Suffolk County Council (20041323)

Post-Hearing Submission for the Third Issue Specific Hearing (ISH3) into Transport and Rights of Way

Bramford to Twinstead (EN020002)

Deadline 4

Works Plans [APP-010]

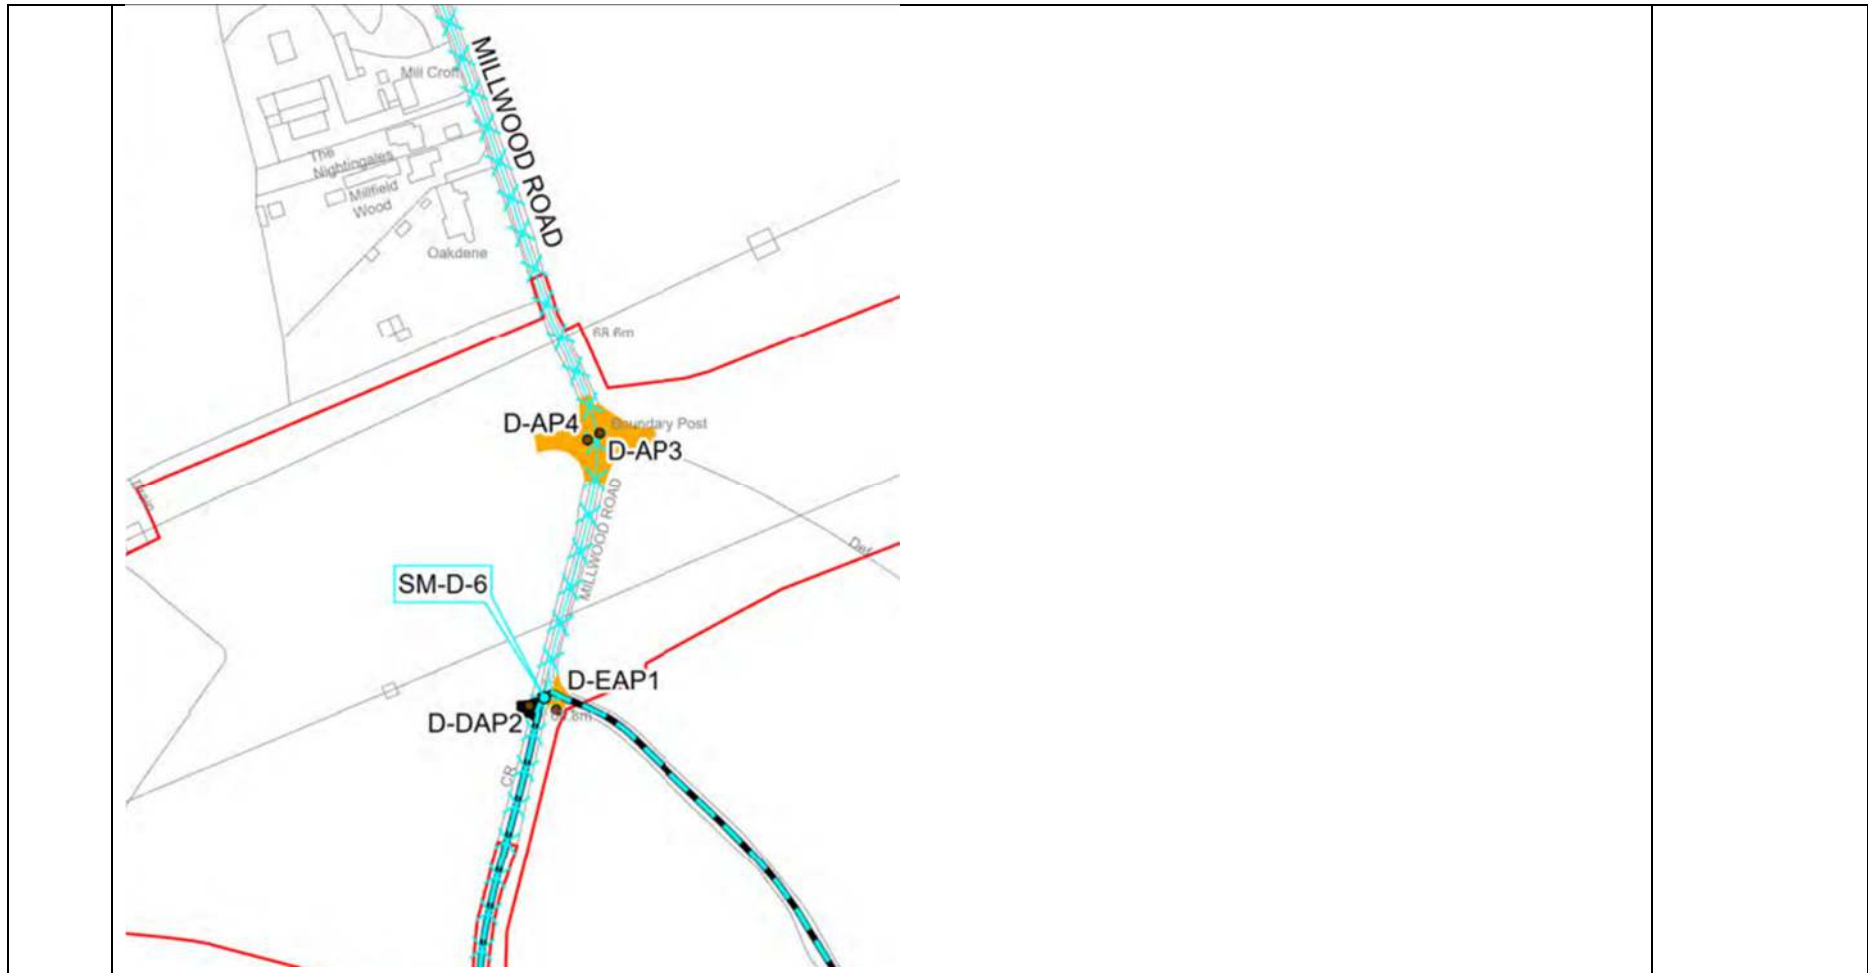
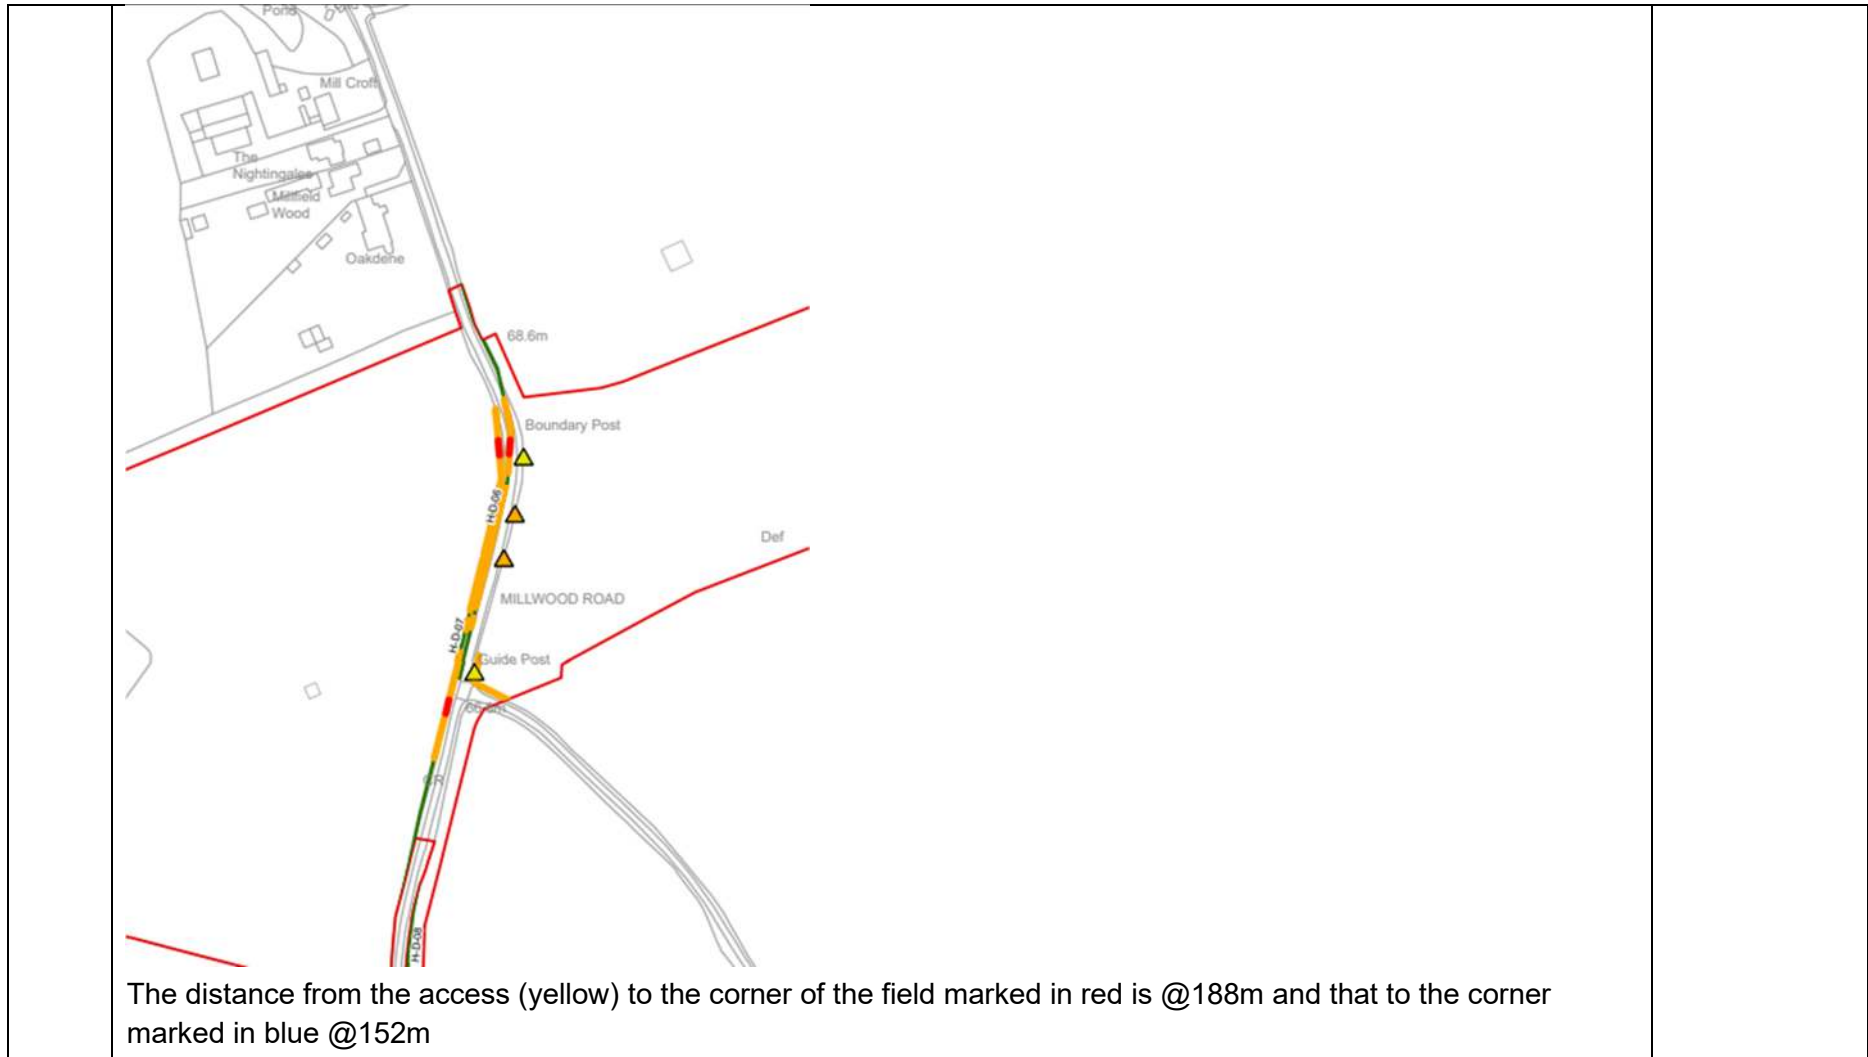
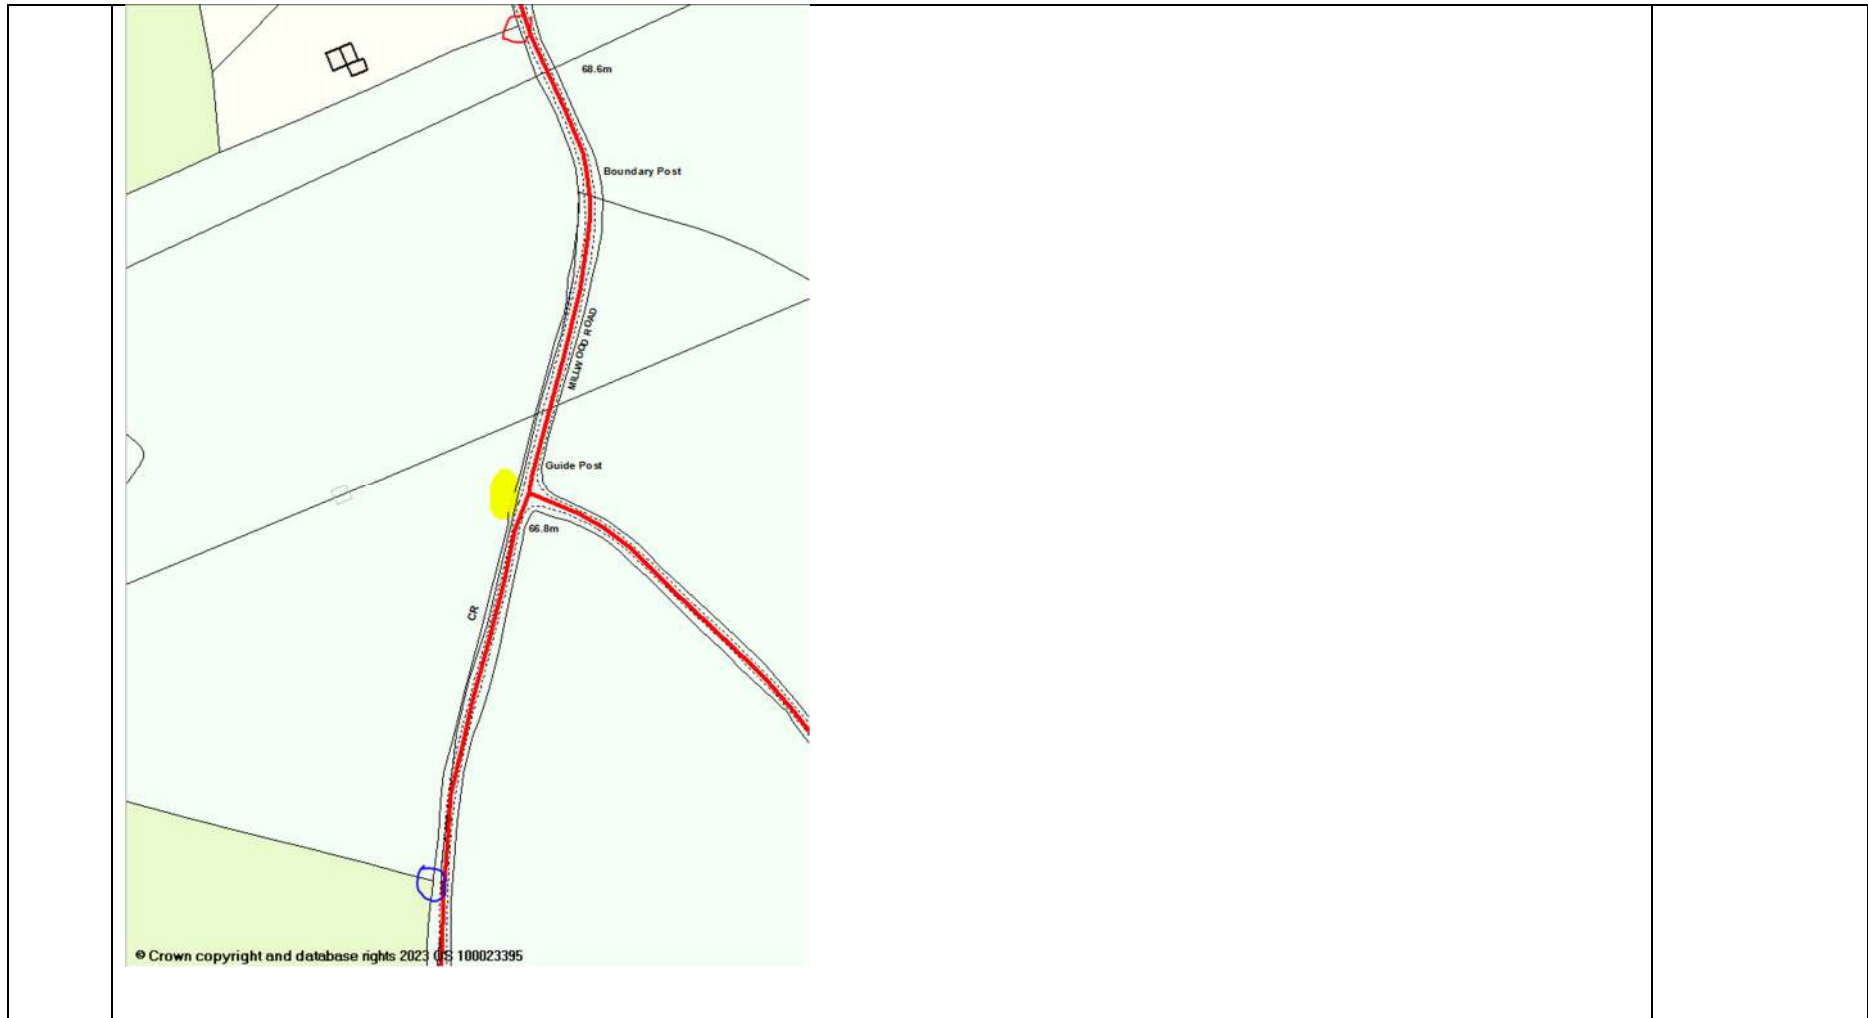
The plans provided are of such large scale to make it difficult to measure the areas proposed for visibility splays.

An example from Church Hill, Burstall in our option shows the issues. The road is currently derestricted but will be subject to a temporary 30mph limit during construction. Even allowing for such a temporary speed limit having good compliance, this will still require a 2.4m x 90m visibility splay as required as by the Suffolk Design Street Guide 2022 Appendix F (see Appendix 1). This would necessitate significant trimming if not removal of trees and hedges. SCC also notes that pollarding / raising the crown of trees whilst practical for individual trees would not resolve the visibility issues if there were a line of trees.
